**NO. 79 (LOT NO. 6) AND NO. 81 (LOT NO. 7) LEACH
HIGHWAY, WILLAGEE WA 6156
CHILD CARE CENTRE**

Form 1 – Responsible Authority Report
(Regulation 12)

The image below shows the fencing elevation along Leach Highway. The coloured infills shown below will be Perspex opaque screening, to allow some natural light and permeability through to the building.

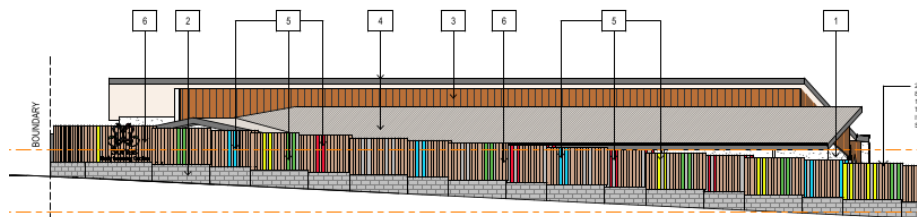
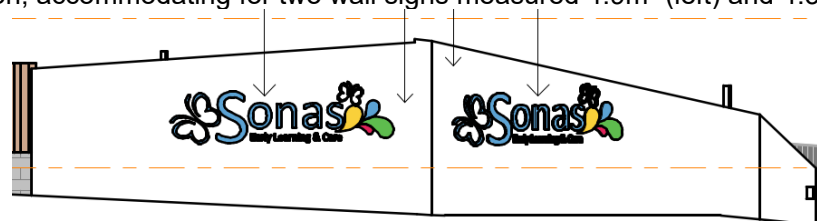
As stated above, a minimum 2.4 metre high predominately solid fence is proposed along the entire Leach Highway street boundary and continues along a portion of the Webber Street frontage. The fencing has been designed to provide an acoustic noise barrier for the outdoor play area.

The fencing design also includes a maximum 3.3 metre solid wall on the corner lot truncation, accommodating for two wall signs measured 4.9m² (left) and 4.3m² (right).

- Maximum 2.4 metre high non-permeable fencing along Leach Highway;
- Fencing on corner lot truncation accommodating signage measured a maximum 3.3 metres high; and
- Maximum 1m high signage wall within driveway truncation

- The height of the walls and their lack of permeability results in poor streetscape surveillance to Leach Highway.
- The solid walls and excessive heights are a design response to achieve compliance with the *Environmental Protection (Noise) Regulations 1997*. Despite the height of the fence proposed the development still does not achieve the desired noise target for the outdoor play area;
- ; and
- The fence results in an obstruction to sight lines being a solid wall greater than 0.75 metres in height with limited visibility provided.

The City has no concerns with the signage on the building but does not support the extent of signage on the solid truncation fencing. The signage is considered excessive by way of its size and nature and is therefore forms a reason for refusal.
